**Notice of Allowability**

09/965,524

ROWE, RICHARD E.

FIGURE 7

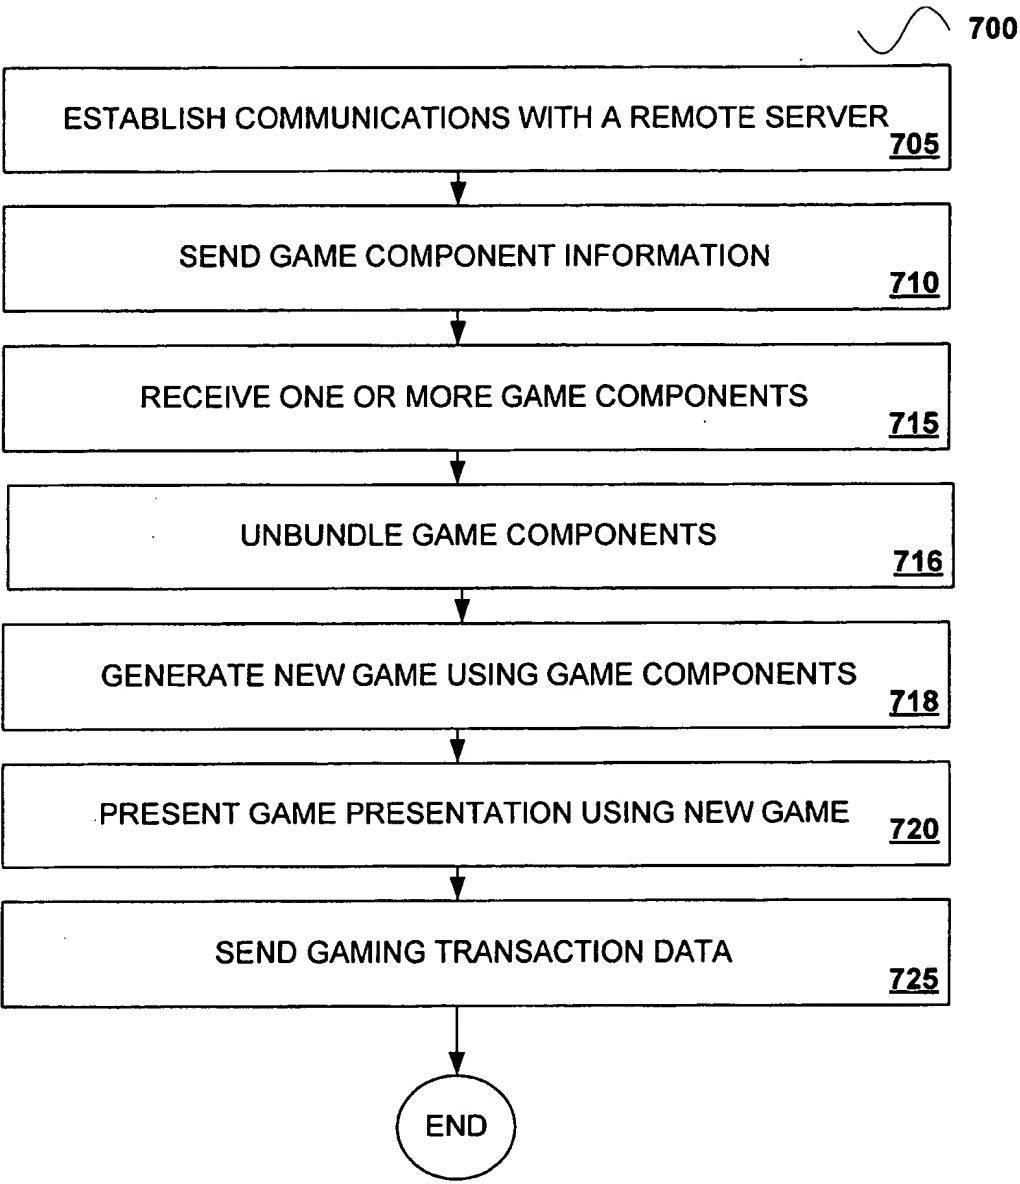
3. The drawings are objected to as failing to comply with 37 CFR 1.84(p)(4) because reference character "710" has been used to designate both step to 'transmit selected items to gaming site' (paragraph 68, fig. 7) and step to 'send game component information' (paragraph 82, fig. 9). Corrected drawing sheets in compliance with 37 CFR 1.121(d) are required in reply to the Office action to avoid abandonment of the application. Any amended replacement drawing sheet should include all of the figures appearing on the immediate prior version of the sheet, even if only one figure is being amended. Each drawing sheet submitted after the filing date of an application must be labeled in the top margin as either "Replacement Sheet" or "New Sheet" pursuant to 37 CFR 1.121(d). If the changes are not accepted by the examiner, the applicant will be notified and informed of any required corrective action in the next Office action. The objection to the drawings will not be held in abeyance.

4. The drawings are objected to under 37 CFR 1.83(a) because they fail to show fig. 9 (it is noted a new figure 7 was provided that may have included a typographical error of '7' for --9-- as described in the specification. Any structural detail that is essential for a proper understanding of the disclosed invention should be shown in the drawing. MPEP § 608.02(d). Corrected drawing sheets in compliance with 37 CFR 1.121(d) are required in reply to the Office action to avoid abandonment of the application. Any amended replacement drawing sheet should include all of the figures appearing on the immediate prior version of the sheet, even if only one figure is being amended. The figure or figure number of an amended drawing should not be labeled as "amended." If a drawing figure is to be canceled, the appropriate figure must be removed from the replacement sheet, and where necessary, the remaining figures must be renumbered and appropriate changes made to the brief description of the several views of the drawings for consistency. Additional replacement sheets may be necessary to show the renumbering of the remaining figures. Each drawing sheet submitted after the filing date of an application must be labeled in the top margin as either "Replacement Sheet" or "New Sheet" pursuant to 37 CFR 1.121(d). If the changes are not accepted by the examiner, the applicant will be notified and informed of any required corrective action in the next Office action. The objection to the drawings will not be held in abeyance.

Not Accepted/Approved *MLL*  
8/30/06
